BROWNS FERRY NUCLEAR PLANT (BFN) – UNITS 1, 2, AND 3 – TECHNICAL SPECIFICATIONS (TS) CHANGES TS-418 AND TS-431 – EXTENDED POWER UPRATE (EPU) – RESPONSE TO ROUND 23 REQUEST FOR ADDITIONAL INFORMATION (RAI) REGARDING STEAM DRYER SIGNAL PROCESSING (TAC NOS. MD5262, MD5263, AND MD5264)

**TENNESSEE VALLEY AUTHORITY
BROWNS FERRY NUCLEAR PLANT (BFN)
UNITS 1, 2, AND 3**

**TECHNICAL SPECIFICATIONS (TS) CHANGES TS-431 AND TS-418
EXTENDED POWER UPRATE (EPU)**

**RESPONSE TO ROUND 23 REQUEST FOR ADDITIONAL INFORMATION (RAI)
REGARDING STEAM DRYER SIGNAL PROCESSING**

Figure EMCB.202/163-4a. Cross Spectra for BFN1 main steam line A: magnitude (top) and phase (bottom) for CLTP (black) and LF (blue) conditions, with notch filtering.

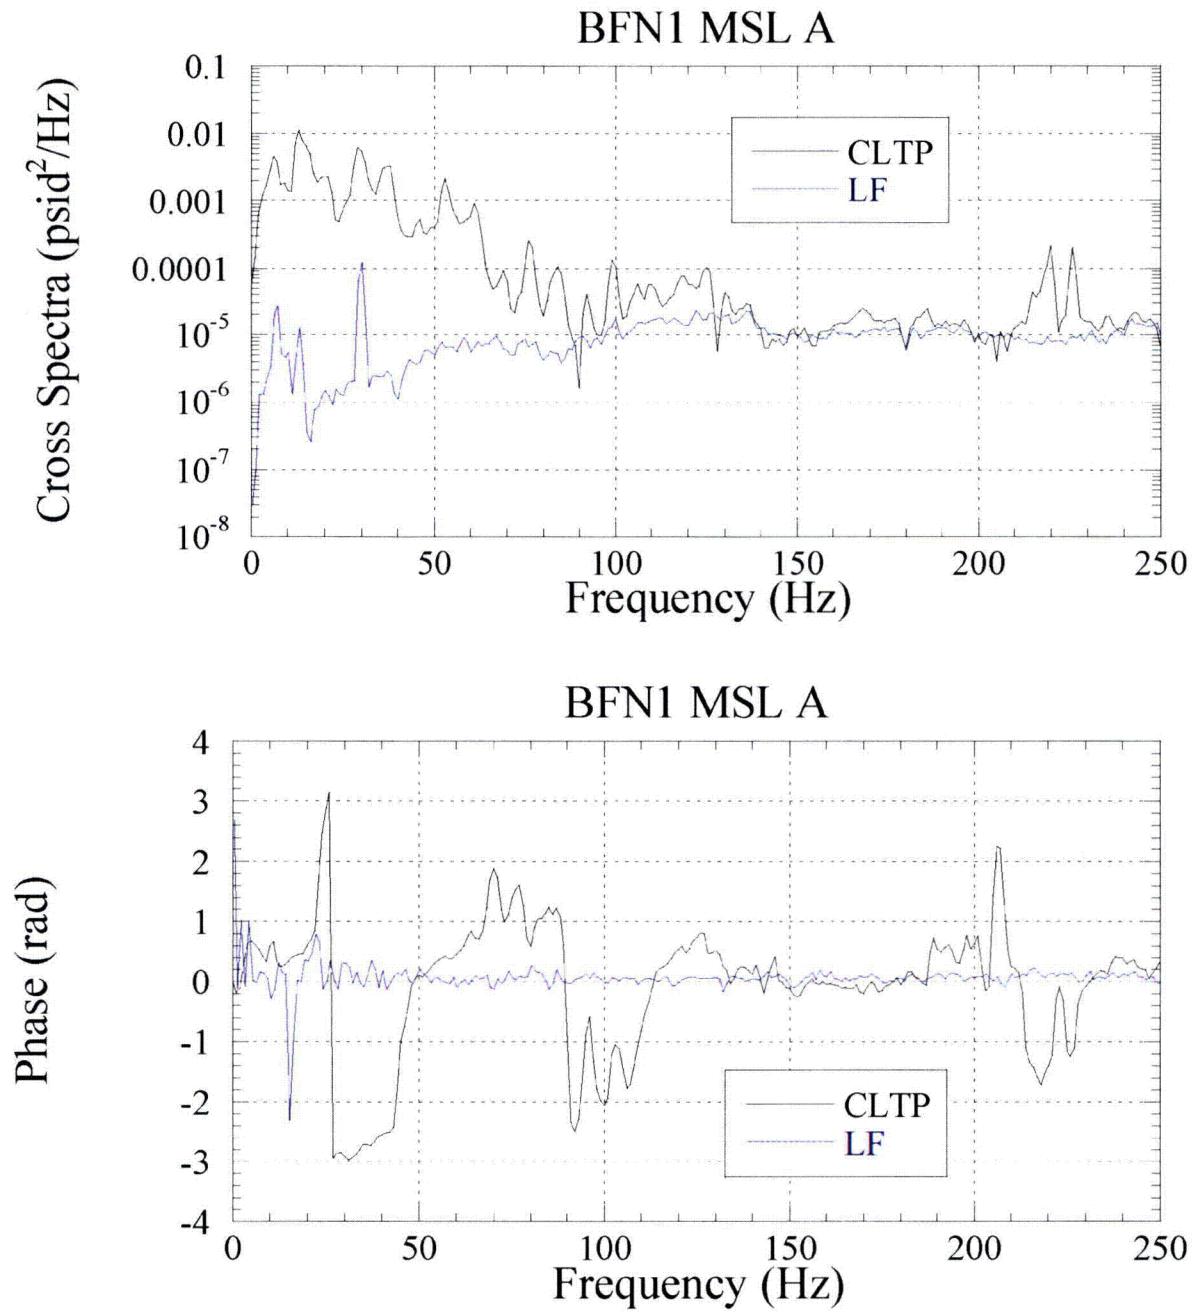
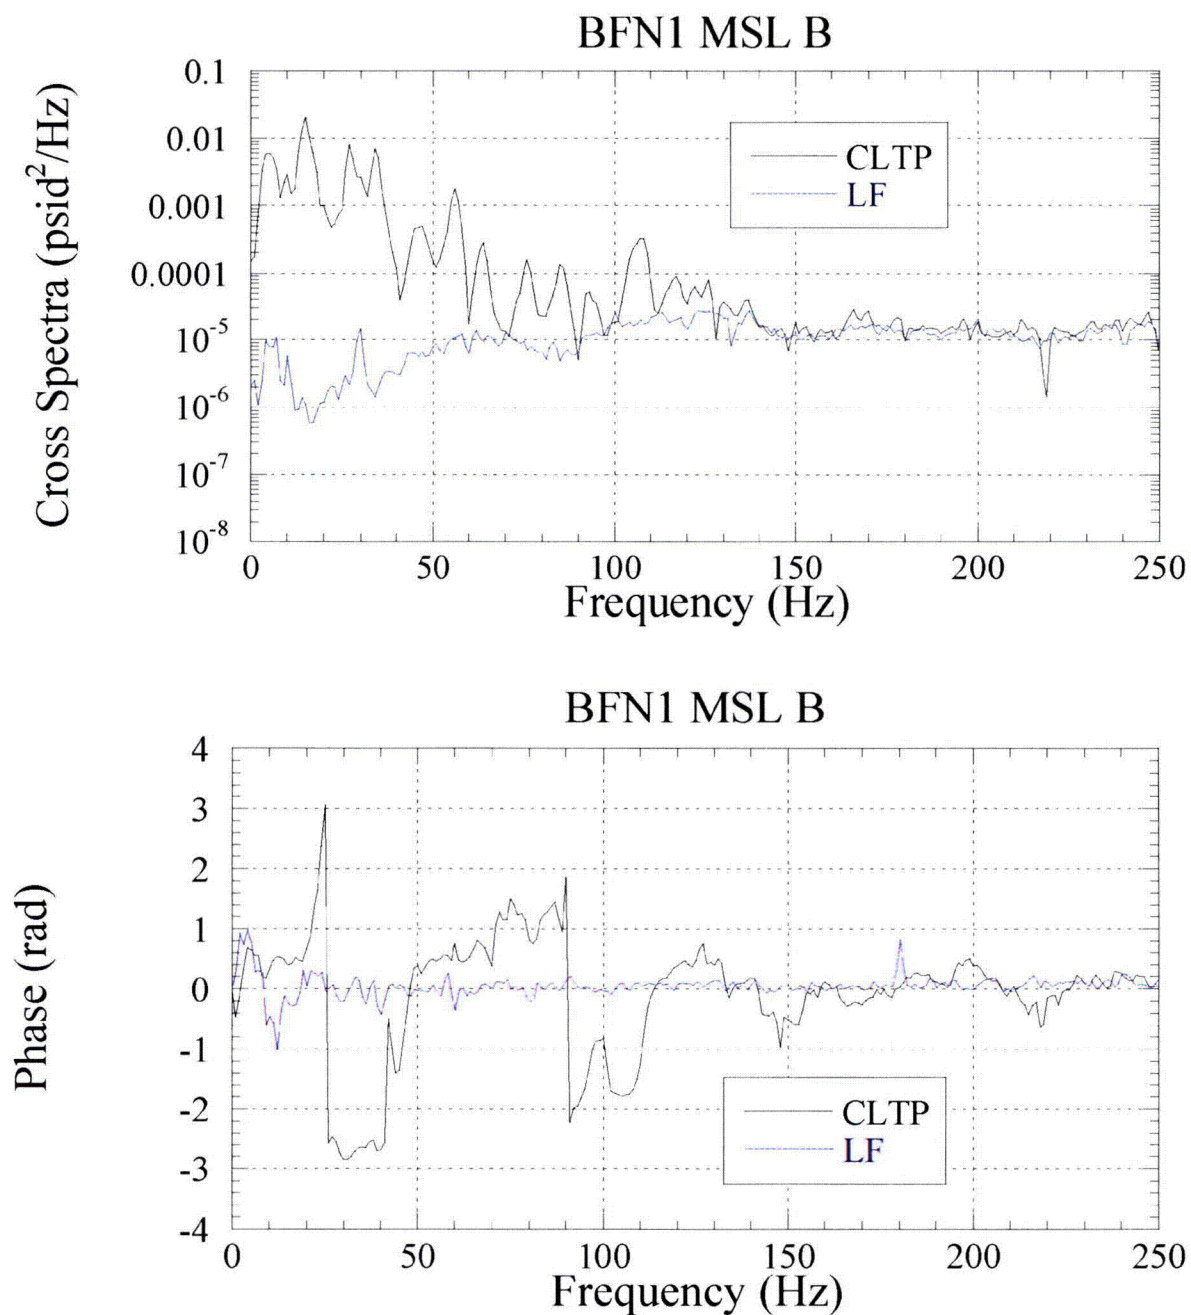
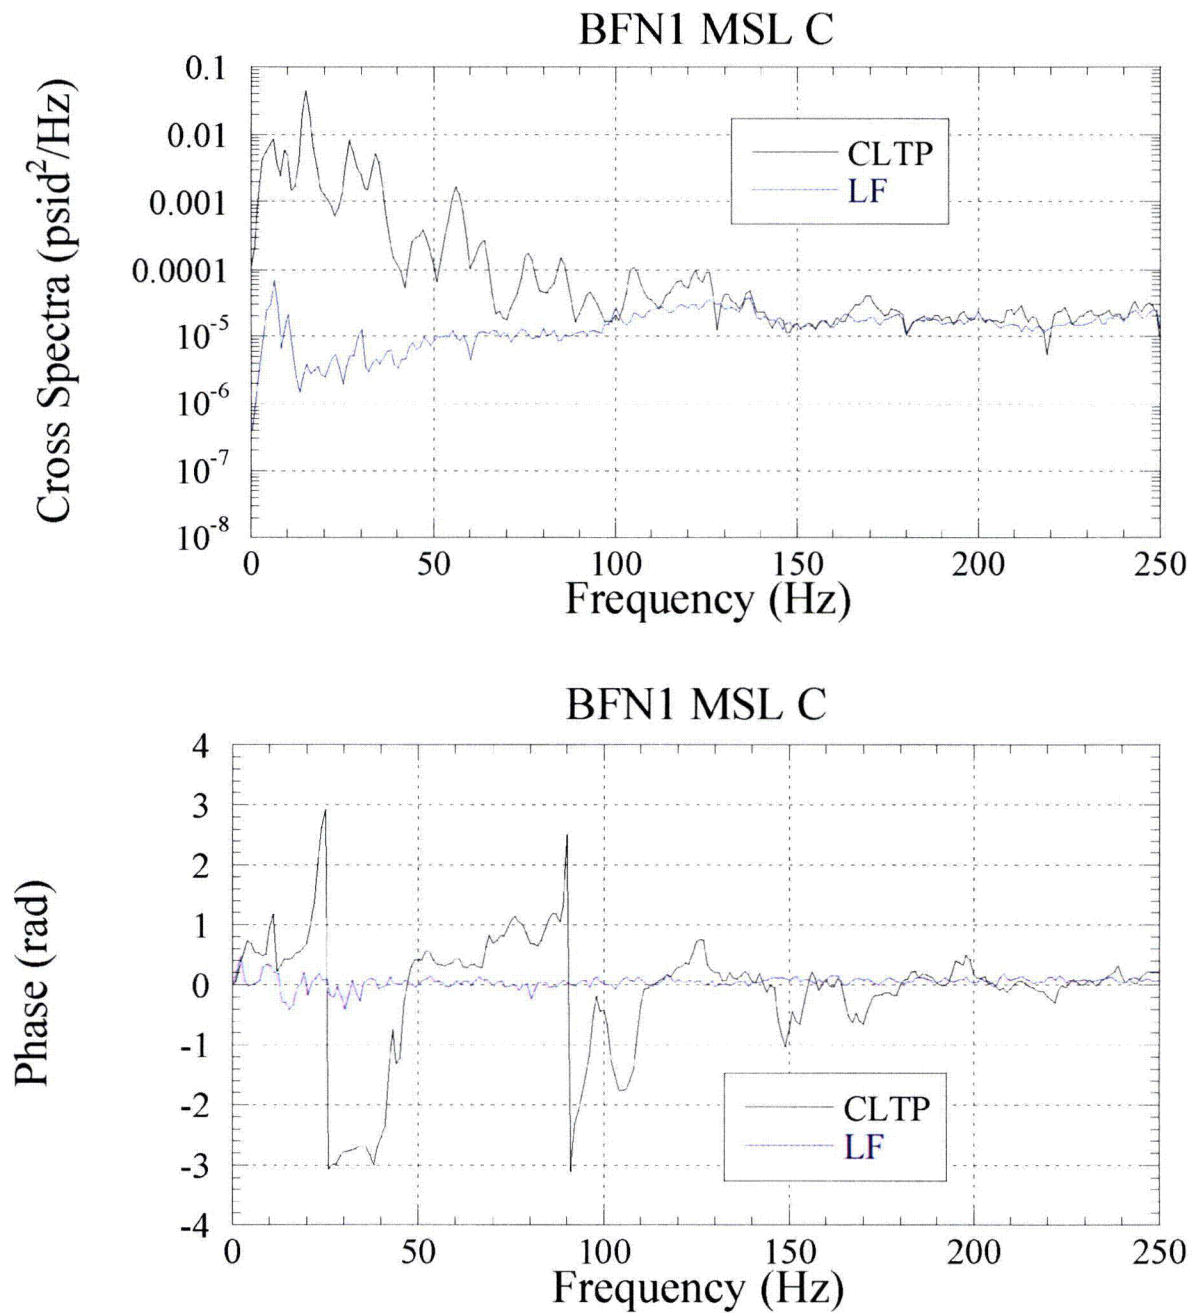
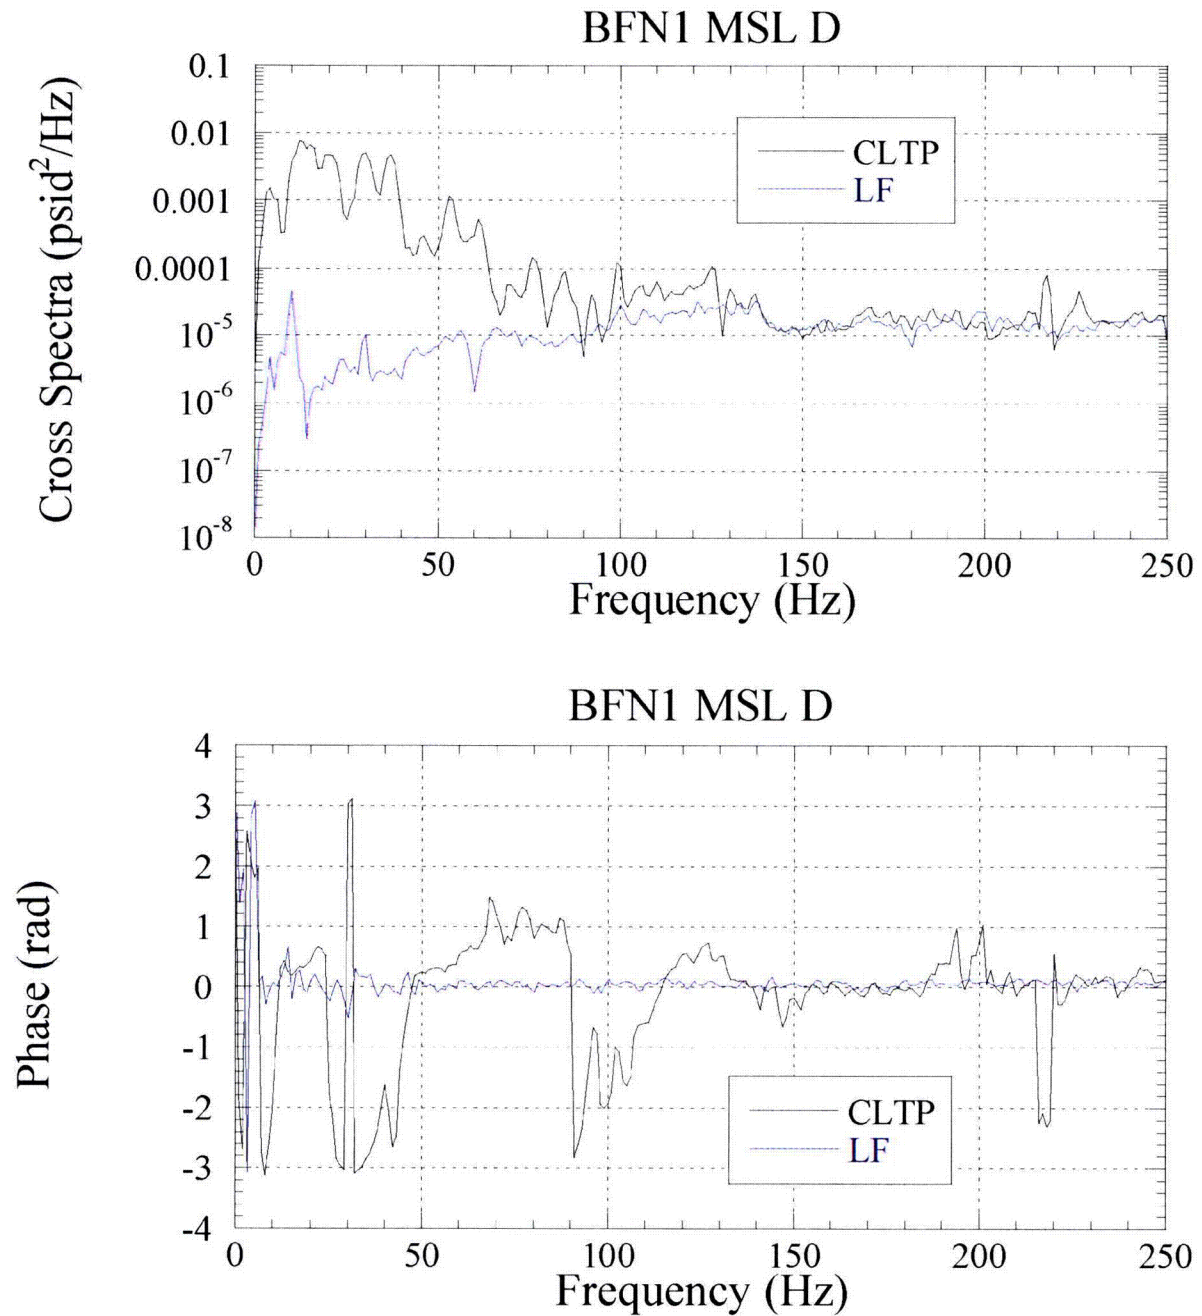
where G_{12} is the cross-spectrum between the two signals, and G_{11} and G_{22} are the autospectra of the individual signals. Explain how G_{12} is modified after using EIC signals and notch filters prior to being used in the coherence calculation. This explanation should include how both the magnitude and phase of G_{12} are modified.

In Figures EMCB.202/163-4a through 4d, the cross spectra magnitude and phase are shown after notch filtering for the CLTP and LF data. One could compare the cross spectra before and after notch filtering by comparing Figures EMCB.202/163-3 and 4. At this point, the coherence
